Errata

SLG46517

CE-GP-001

This document contains the known errata for SLG46517 and the recommended workarounds.

Figure 1

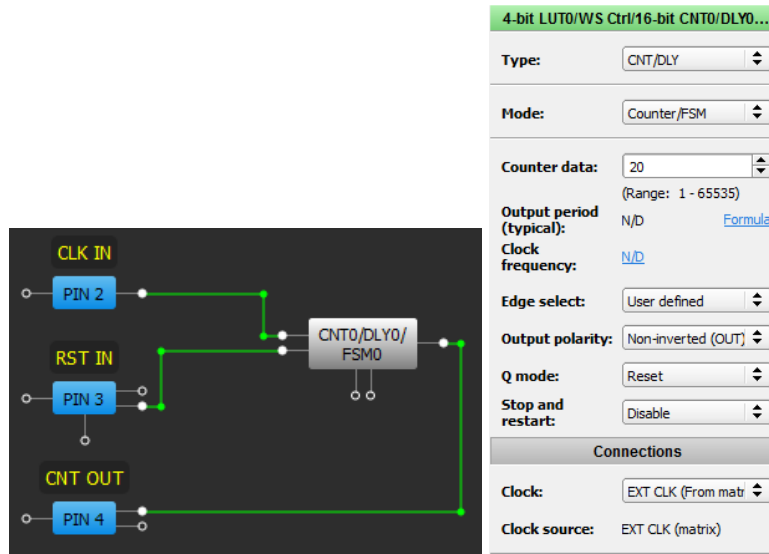
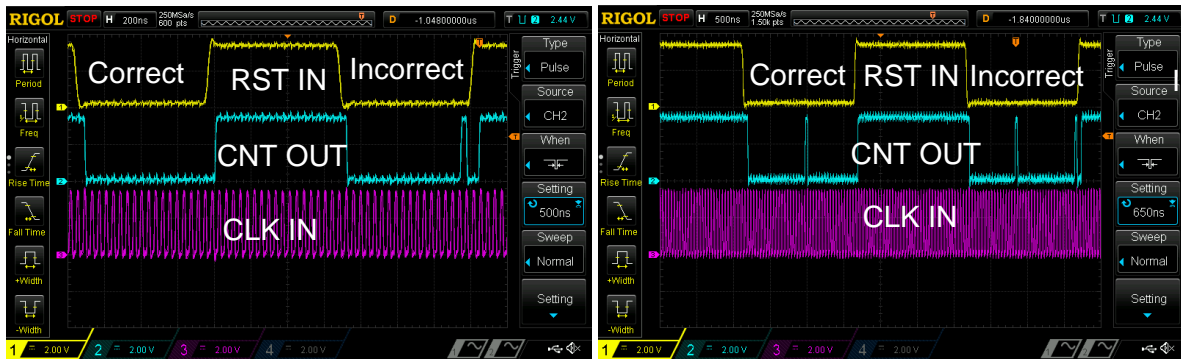
If the Counter Reset is asserted at the same time as a rising clock edge, it is possible that the Counter Data will be reset incorrectly and the counter output may appear faster than expected. This phenomenon appears more often as the clock frequency increases.

Synchronize RESET input of the Counter with its CLK using 2 DFF cells as shown on Figure 3.

Figure 4

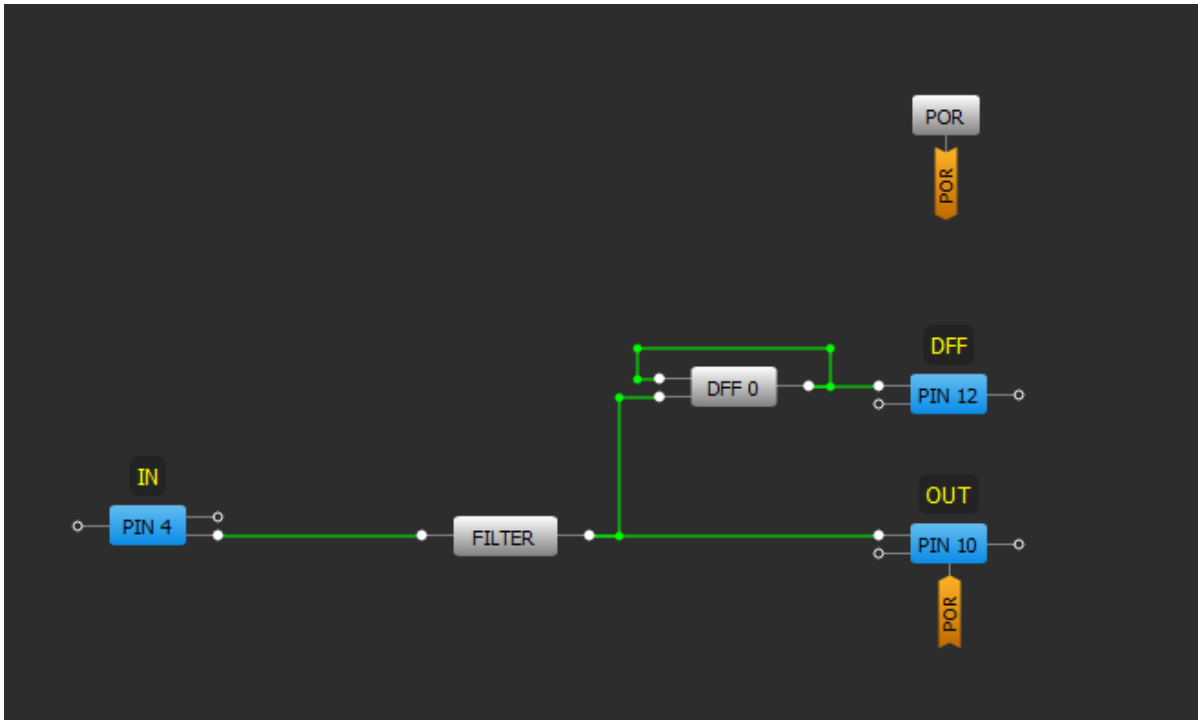
If clock type high frequency input comes in, the FILTER cell may not filter out it. There are several factors like input frequency, duty cycle and LOW duration in such signal that may lead to its passing through FILTER block.

1. Period is 60ns. Pulse width is 10ns DC=16.7% (Correct functionality)

Currently there is no workaround for this issue. Filter block is good at filtering short spontaneous glitches. It is intended to be used in series connection before the delay cell to avoid its latching.

Figure 8

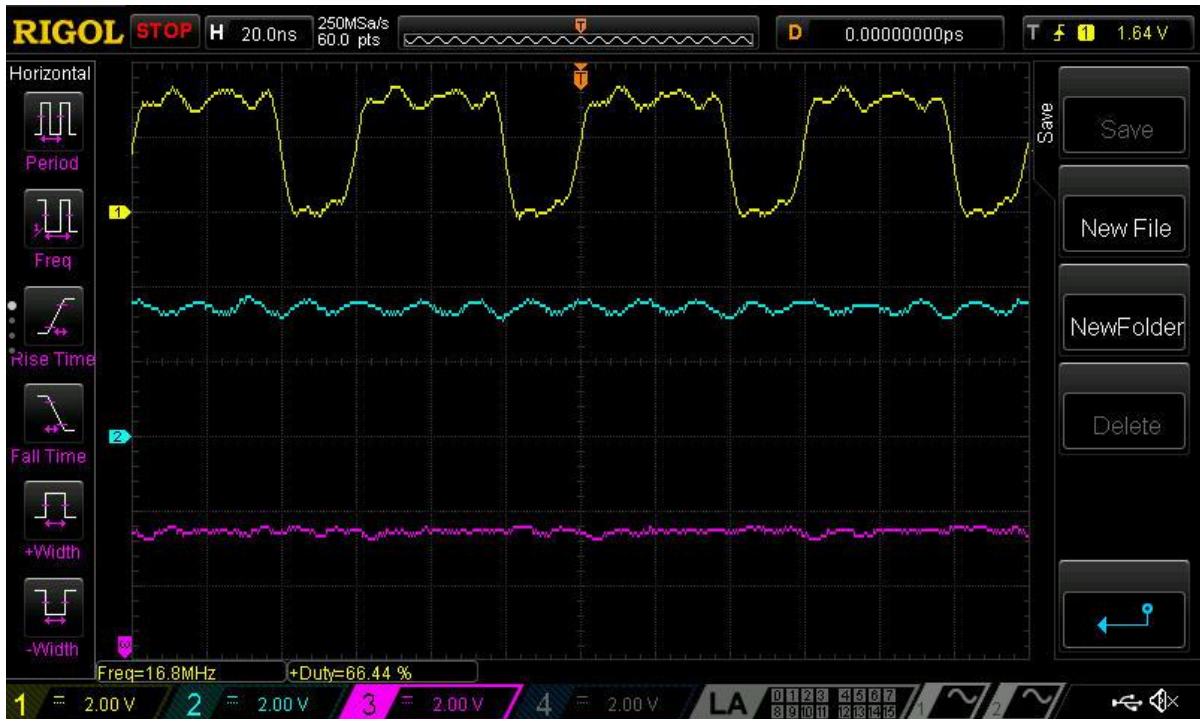
4. Period is 60ns. Pulse width is 40ns DC=66.67% (Correct functionality)

Figure 9

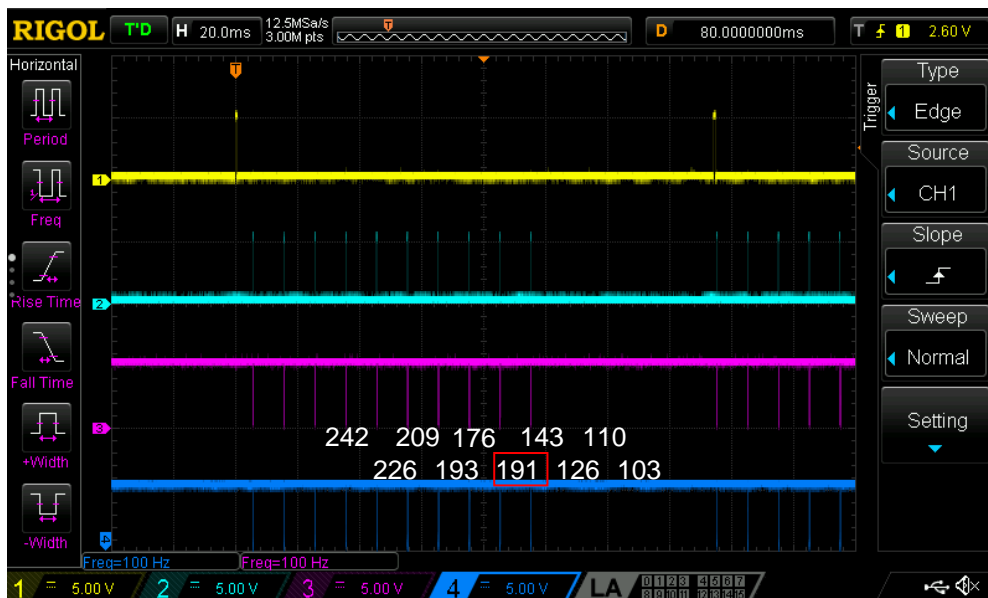
The example data capture below shows ten periodic I2C reads of CNT2/DLY2 configured to count down at about 16 clocks per read. The sixth read sample erroneously shows a value greater than that of the fifth. The seventh sample reads as if the previous I2C error never occurred - the difference from the fifth sample (176) to the seventh (143) is 33 clocks or 16 clocks + 17 clocks as expected.

If the possibility of incorrect I2C data reads can't be accommodated for by external software checks, one can guarantee proper operation by stopping the CNT/DLY block's clock during I2C reads

through one of the following methods: by disabling the oscillator block, by reconfiguring the CNT/DLY block's clock source, or by gating an external clock using a LUT (Look-up Table) in the signal matrix. After disabling the CNT/DLY block's clock, the count registers can be read without error. Please note that this workaround will add the I2C read and processing time to the counter's overall clock period.

Figure 10: I2C Write of 16-Bit Counter Data Example

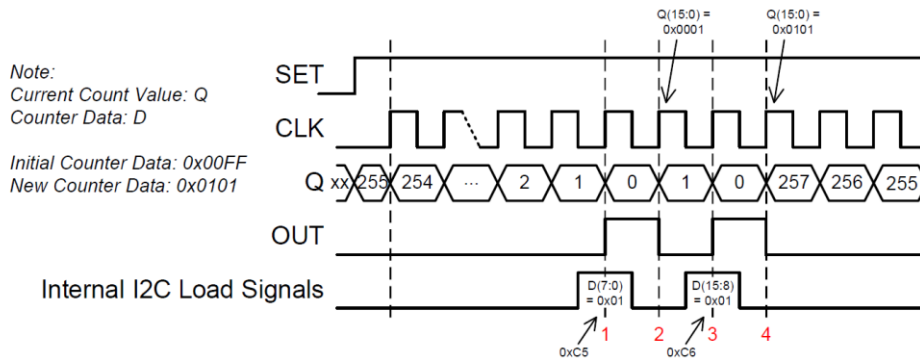
The timing diagram in [Figure 10](#) sets up a case where an improper output will be seen on the counter. In this example, the initial Counter Data value (D) is set up as 0x00FF. As you can see, the

Current Count Value (Q) decrements from 255 down to 0 with rising edges on CLK. At time “1” denoted by a red number 1, an I2C command (not shown) has just been sent to the GreenPAK device to reconfigure the Counter Data value to 0x0101.

As previously mentioned, the 16-bit value is loaded from the I2C buffers to the Counter Data registers in 8-bit chunks. Right at time “1”, the LSB byte (0x01) is loaded into the Counter Data registers. This makes the Counter Data value temporarily equal to 0x0001. At time “2” between the internal I2C load signals, the counter receives a rising edge on its clock input. This causes the Current Count Value to underflow and to be loaded with the Counter Data value which is 0x0001. At time “3”, the MSB byte (0x01) is loaded into the Counter Data registers setting the Counter Data value to 0x0101. At time “4”, the Current Count Value underflows again and is set to the Counter Data value of 0x0101.

won't be gated internally which avoids the loss of count values during Tstop. In order to guarantee the current count value after an I2C write to the Counter Data registers, the clock should be manually stopped for the I2C write or a SET/RESET command should be generated after the I2C write. (Case 1)

Figure 12: Counter Behavior

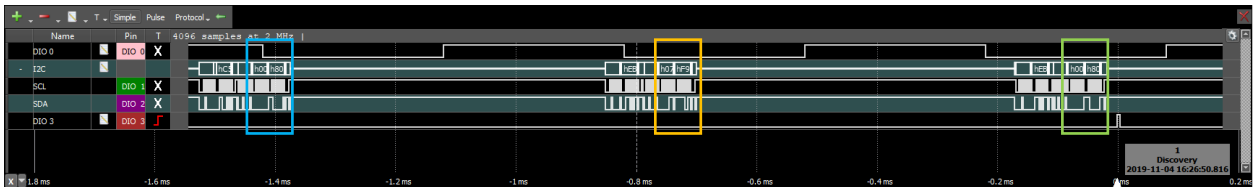
For the following condition, the Counter Data register contents are unexpectedly loaded into the counter's DFF chain. This behavior occurs when there is a falling edge on the counter block's clock input during the data return portion of an I2C read of the Counter Data registers. Figure 10 shows this falling edge boxed in light blue followed by two I2C reads of the Current Count Value registers.

As you can see by the MCU data log below, the Current Count Value gradually increases from 0xF904 to 0xF907 but is unexpectedly reset to 0x8000. Please note that the colored HEX values in the MCU Log correspond to the boxed I2C read commands shown in the waveform above. As previously described, this reset occurs because there is a falling edge on the counter's clock input while the GreenPAK device is responding to an I2C read request to 0xC5 and 0xC6. (Note that 0xC5/0xC6 are the Counter Data registers and 0xEB/0xEC are the Current Count Value registers for CNT0.)

For systems that require I2C write access to the Counter Data registers while the counter is clocking, enable the "Stop and Restart Bit." (Case 2)

I2C Read of Counter Data: Avoid reading Counter Data via I2C while the counter is being clocked.

Within the MCU, we recommend saving the Counter Data register configuration as a software variable so that the Counter Data register doesn't need to be read during counter operation.

Figure 11

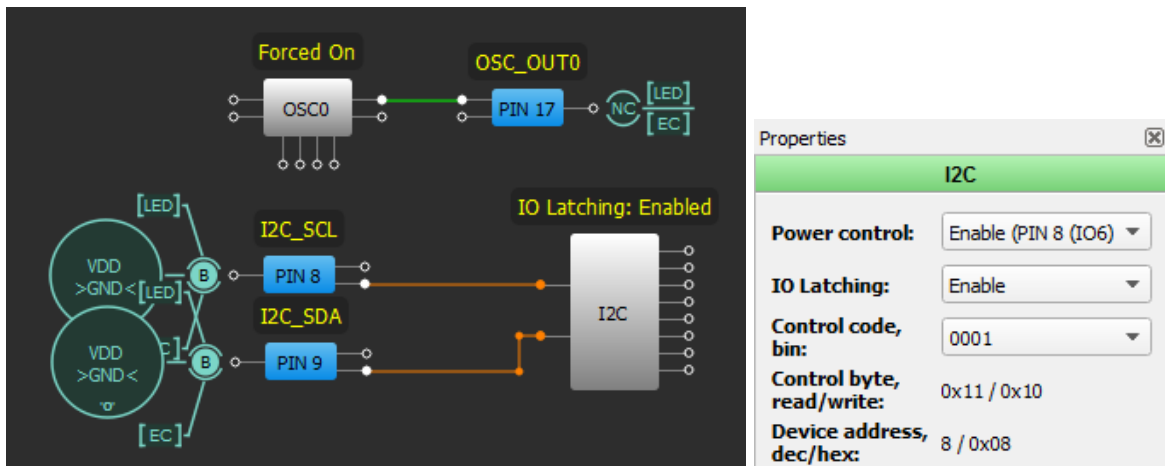
In the example below, we will be monitoring the OSC output, which is measured by a scope on Channel 3 via PIN17 ("OSC_OUT0"). The I2C bus will be forced low to create a START bit.

By toggling I2C_SDA low and then I2C_SCL low, the GreenPAK registers this as a start bit and latches all General Purpose Outputs such as PIN#17(“OSC_OUT0”). In the Figure 12, notice that PIN#17 (OSC_OUT0) stops toggling.

Disable IO Latching in programmed OTP. This register is I2C-write locked during normal operation and therefore should be disabled in configuration file.
 Do not share I2C bus with other devices and make sure the I2C bus is not powered down while the GreenPAK is still powered through VDD.

If the above cannot be satisfied, then consider using the SLG4658x devices, where this errata has been fixed.
